COMMONWEALTH of VIRGINIA
DEPARTMENT OF TRANSPORTATION

October 29, 2010

**Stafford County, Virginia Comprehensive Plan 2010-2030
VDOT Fredericksburg District Review**

ROUTE 1 – STAFFORD COUNTY
VDOT RECOMMENDED MINIMUM TYPICAL SECTION
URBAN DIVIDED SIX-LANE HIGHWAY WITH RAISED MEDIAN
(28’ WIDE TO ACCOMMODATE DOUBLE-LEFT-TURN LANES)
PLUS SIDEWALK AND MULTI-USE TRAIL
 NOTE: AUXILIARY LEFT AND RIGHT TURN LANES NOT ILLUSTRATED

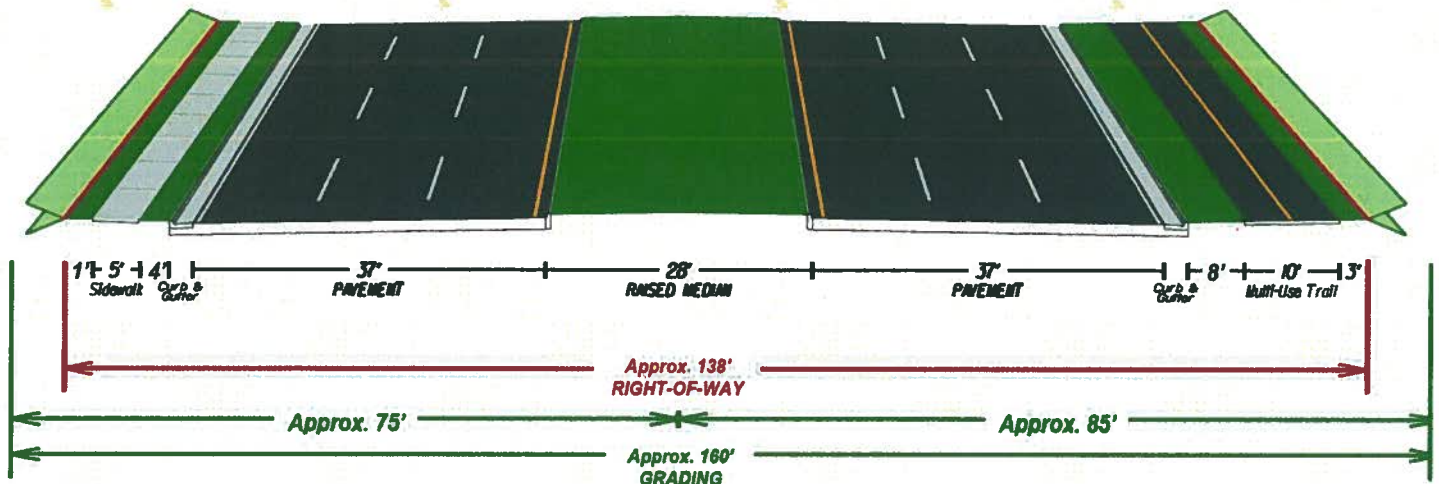
According to VDOT’s traffic engineering section, Route 1 is classified as an Urban Principal Arterial Highway throughout Stafford County. The 2035 George Washington Regional (FAMPO) Long Range Transportation Plan shows the entire length to be “Partially Funded in Constrained Plan” for improvements. Figure 4.2 of the Comp Plan (road improvement projects in approved funding programs) indicates that only a tiny portion of Route 1 falls into a funded category. Generally, the appropriate typical section for these improvements is a six-lane urban design. The FAMPO Bike and Pedestrian Plan calls for the accommodation of bicycles and pedestrians on “Shoulder Improvements” for most of Route 1 in Stafford County. However, the designation of Route 1 as an urban highway (with the typical use of curb and gutter and sidewalks in lieu of shoulders), may require a modification to this plan. The “ultimate” typical section for Route 1, illustrated below, is appropriate and desirable in a majority of locations. VDOT Geometric Standard GS-5 (Urban Principal Arterial System) allows for the use of shoulders (currently 10’ wide) and ditches, but the curb and gutter/storm sewer option can reduce the Right-of-Way impacts. When roadside ditches are utilized, RW is normally acquired beyond the farthest point of grading, whereas with curb and gutter, the RW Line is normally placed at the back of the sidewalk space and slopes are constructed on temporary easements. The median width may be reduced to 16’ in areas where dual left turn lanes are not needed. Normally, 12’ of additional RW width will be needed where right turn lanes are required. Intersections will require additional width of RW, varying by situation. In commercial corridors, a continuous right turn lane may be desirable. The typical section below includes the latest revisions to VDOT Design Standards as of October 2010. This typical section would provide the facility illustrated in Figure 4.1 of the Comp Plan entitled, “Anticipated Transportation Needs”.

Route 1 is the only existing highway with significant capacity running parallel to I-95. Therefore, it is the only option for I-95 incident management, at this time, and will likely continue to fill that role indefinitely. All improvements to Route 1 in Stafford County should include features that will accommodate an emergency situation on I-95 to the fullest extent practical, including large-radius turning movements at all connecting roadways on which interchanges with I-95 are located.

ROUTE 17 – STAFFORD COUNTY
VDOT RECOMMENDED MINIMUM TYPICAL SECTION
URBAN DIVIDED EIGHT-LANE HIGHWAY WITH RAISED MEDIAN

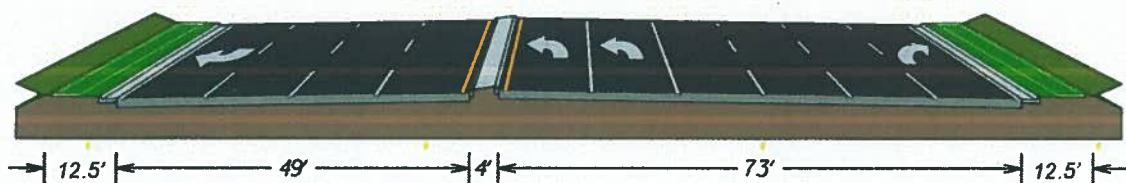
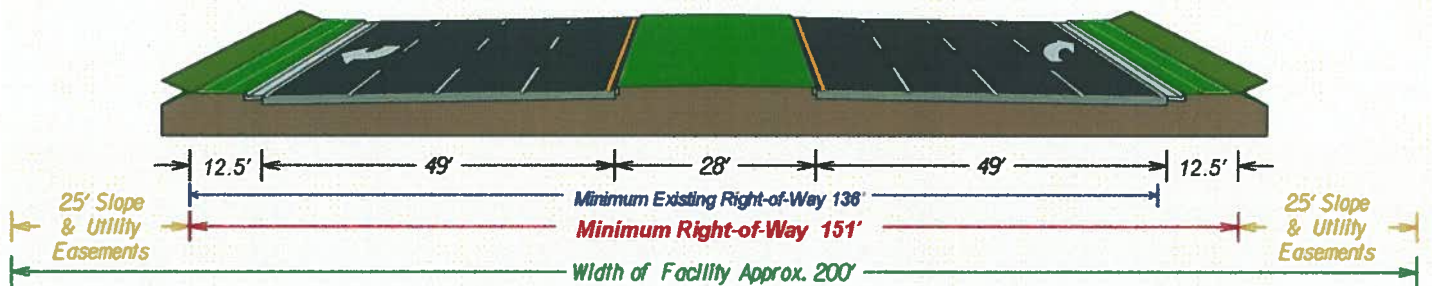
Route 17, excluding Route 17 Business, is classified as either an Urban Principal Arterial Highway or Rural Principal Arterial Highway in Stafford County. The dividing point is just west of the intersection of Village Parkway, with sections eastward designated as urban. Route 17 is also part of the National Highway System. Where Route 17 runs concurrent with I-95, it is classified as an Urban Interstate. Improvements planned for Route 17 include the current VDOT Project UPC #71774 which will add one additional through lane in each direction, a continuous right turn lane in each direction and sidewalks from McLane Drive through Stafford Lakes Parkway, which encompasses a majority of Route 17 that is designated as urban. The typical section shown below represents the current GS-5 Standard for Route 17. The actual typical section for Project UPC #71774 may vary slightly in accordance with Standards applicable during the design phase. This facility is expected to degrade to LOS F at every intersection east of International Parkway by the design year of 2034 unless additional capacity is provided.

A future improvement listed on the 2035 George Washington Regional Commission Constrained Long Range Plan is the widening of Route 17 westward from the aforementioned VDOT Project through Route 612, Hartwood Road. This project is listed in the GWRC CLRP as “Fully Funded in Constrained Plan”. Figure 4.1 of the Comp Plan shows a similar but shorter segment as a “6-Lane Highway Upgrade” that ends just west of Route 616 (Poplar Road) and Figure 4.2 indicates that this section of Route 17 is not included in an approved funding program. Bicycle and pedestrian accommodations are listed in the GWRC Plan as being provided through “Signage”, which could include options such as “share the road” or bicycle accommodation on the shoulder. During the development of VDOT Project UPC #71774, it was determined that there is no safe method of accommodating bicycles within the roadway prism of Route 17 due to automotive vehicle type, vehicle volume, and vehicle speed. The County’s support of providing an alternate, parallel facility, in the form of an off-site multi-use path (or paths) along the current project is an advisable option for other sections of Route 17 and should be considered.
